GAME - Team UPDATE - 2012-02-03	3
GAME - Team UPDATE - 2012-01-31	4
GAME - Team UPDATE - 2012-01-27	6
GAME - Team UPDATE - 2012-01-24	7
GAME - Team UPDATE - 2012-01-20	9
GAME - Team UPDATE - 2012-01-17	12
GAME - Team UPDATE - 2012-01-13	13
GAME - Team UPDATE - 2012-01-10	17
ADMINISTRATIVE - Team UPDATE - 2012-02-03	23
ADMINISTRATIVE - Team UPDATE - 2012-01-20	24
ADMINISTRATIVE - Team UPDATE - 2012-01-17	25

GAME - Team UPDATE - 2012-02-03

Figure 4-8

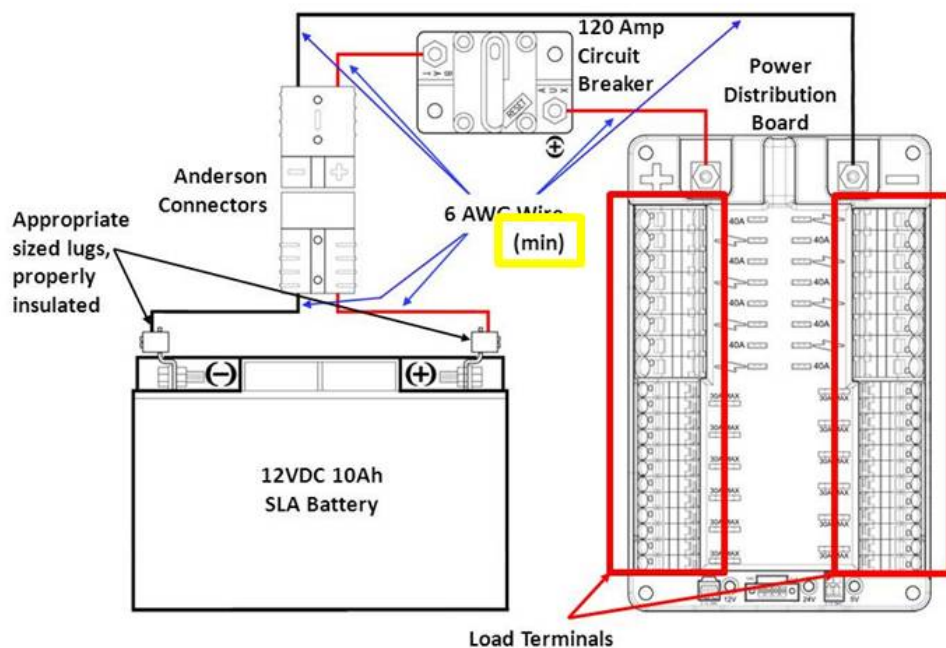
Figure 4-8 was revised to allow wire larger than 6AWG between the battery terminals and the Power Distribution Board terminals.

Figure 4-3

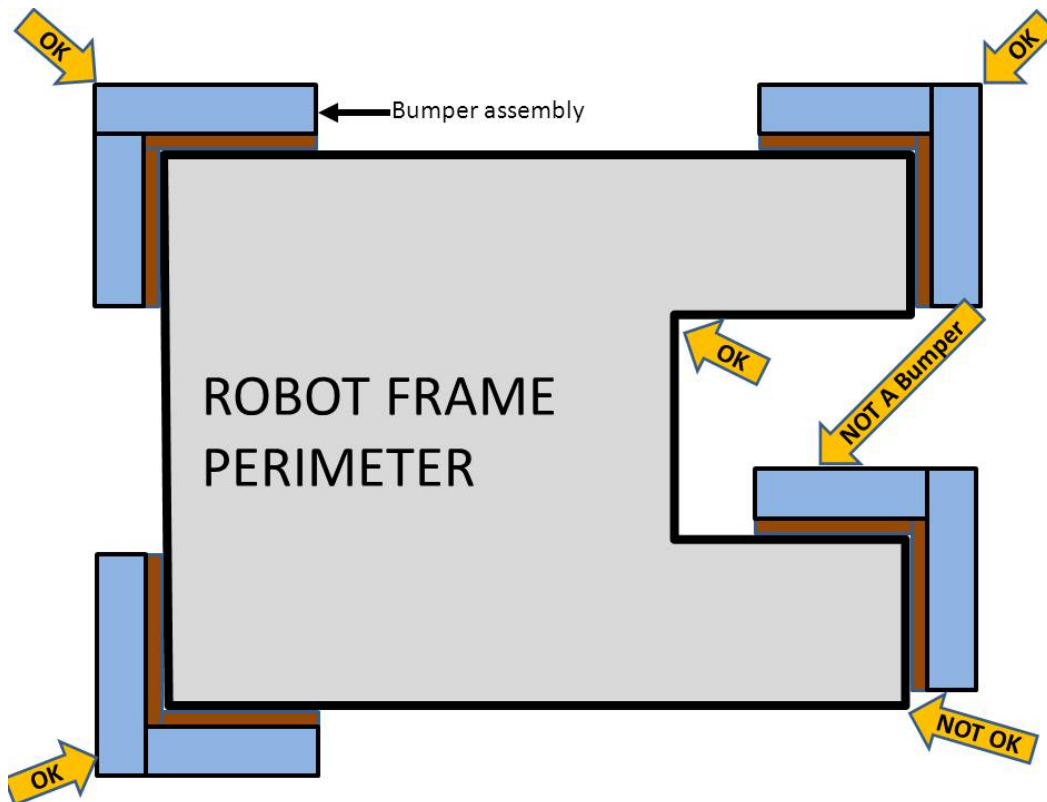
Figure 4-3 has been updated to correct the portrayal of the Frame Perimeter. The image intends to portray a nuance that bumper material assembled per the rules in Section 4.1.6, which is not along the Frame Perimeter, is not considered an official Bumper. Whether in contact with the official Bumper segment that is running along the Frame Perimeter, or not, padding placed inside the Frame Perimeter is not considered an official Bumper and thus Rule [R03-B] does not apply.

Figure 4-3 has been revised to clarify that example padding is legal, but not considered an official Bumper based on its placement.
